### Amendments to the Drawings

# Appl. No. 10/791, 964 Amdt. Dated Aug. 2, 2007 Reply to Office Action of Feb. 2, 2007 Annotated Sheet Showing Changes Made

FIG. 1

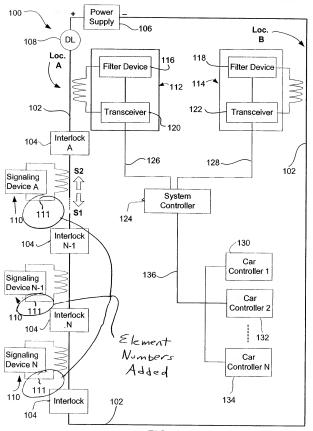
The Examiner has objected to the Drawings under 37 CFR § 1.83(a). Specifically, the Examiner requested that certain elements specified in the claims be shown in the Figures. Regarding the element "rf signals", Applicant has amended the specification (paragraph [0022]) and Figure 1 to include a reference numeral (111) for the rf signal (see Attached Replacement Sheet and Annotated Sheet).
